NEWMAR CORPORATION WARRANTY DEPARTMENT

TECHNICAL SERVICE BULLETIN																			
DATE ISSUED		MODEL YEAR(S) AFFECTED			MODEL(S) AFFECTED			TSB #											
10/26/98		1997-1999			ALL			164											
BRAND					TYPE														
All	<input type="checkbox"/>	American Star	<input type="checkbox"/>	Kountry Star	<input type="checkbox"/>	Dutch Star	<input type="checkbox"/>	All	<input type="checkbox"/>										
NewAire	<input type="checkbox"/>	Mountain Aire	<input checked="" type="checkbox"/>	Kountry Aire	<input checked="" type="checkbox"/>	London Aire	<input checked="" type="checkbox"/>	T T	<input type="checkbox"/>										
								F W	<input type="checkbox"/>										
								C A	<input type="checkbox"/>										
								D P	<input checked="" type="checkbox"/>										
								D B	<input type="checkbox"/>

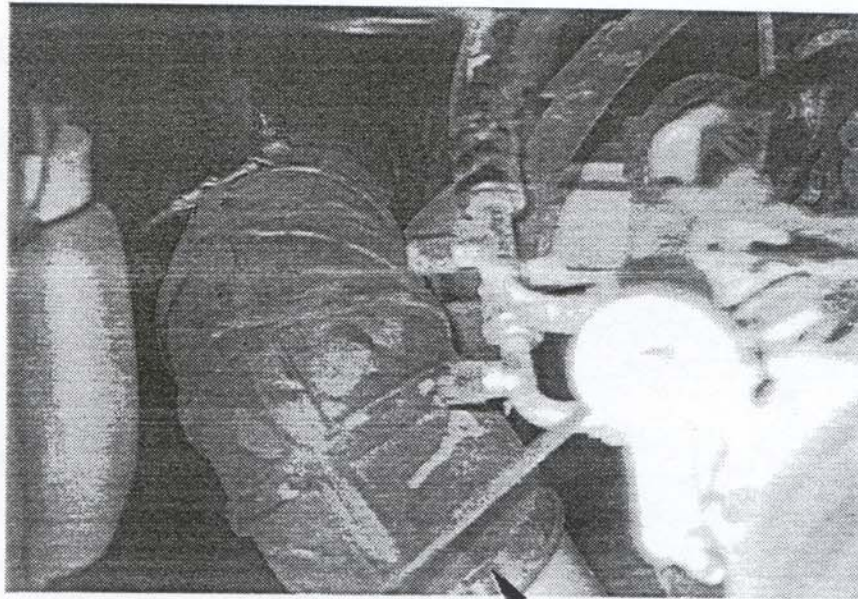
1. Contact Point. Inspect this area. Relocate and strap to create a 1-1/2" to 2" gap between pipes
2. This is the where to attach the clamp and strap.

<input type="checkbox"/> Air Conditioning & Heating	<input type="checkbox"/> Electrical Components	<input type="checkbox"/> Appliances & Accessories	<input type="checkbox"/> Exterior Components	<input type="checkbox"/> Cabinets & Furniture	<input type="checkbox"/> Interior Components	<input checked="" type="checkbox"/> Chassis Components	<input type="checkbox"/> Plumbing & Bath Components	<input type="checkbox"/> Construction Components	<input type="checkbox"/> Windows, Awnings, Vents, & Doors
<input type="checkbox"/> Air Conditioning & Heating	<input type="checkbox"/> Electrical Components																		
<input type="checkbox"/> Appliances & Accessories	<input type="checkbox"/> Exterior Components																		
<input type="checkbox"/> Cabinets & Furniture	<input type="checkbox"/> Interior Components																		
<input checked="" type="checkbox"/> Chassis Components	<input type="checkbox"/> Plumbing & Bath Components																		
<input type="checkbox"/> Construction Components	<input type="checkbox"/> Windows, Awnings, Vents, & Doors																		
DESCRIPTION OF PROBLEM																			
Possible air intake tubes rubbing together.																			
RECOMMENDED SOLUTION																			
See the attached photos. Move the air tube and elbows up to provide 1 1/2" gap. Attach exhaust hanger to top portion of engine compartment just behind the hinge for the bed access. Attach the hanger to the elbow with a clamp or a strong plumbing strap. Use labor code number 15901201, .8 hour when completing this repair.

Clamp
Location

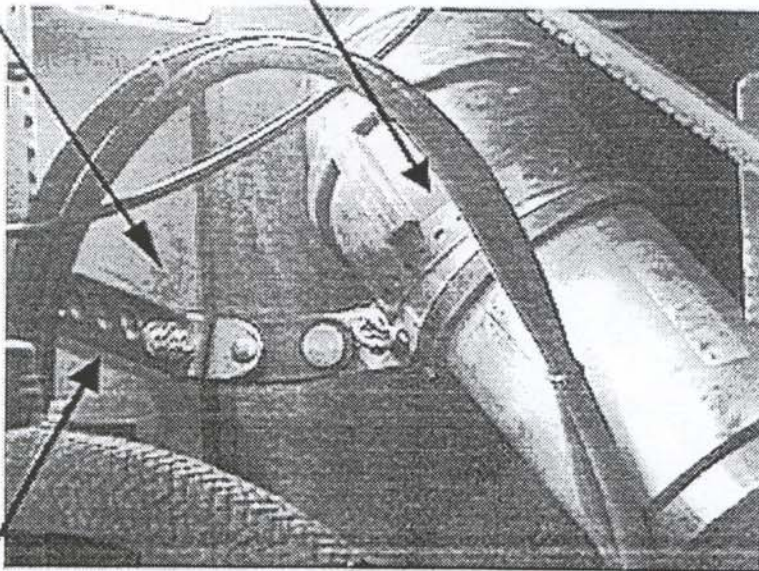
Heavy Gauge Plumbing
Strap or Hose Clamp

Attach to Top of Compartment
Area Behind Bed Hinge

Exhaust System Hangar
with Rubber Swivel
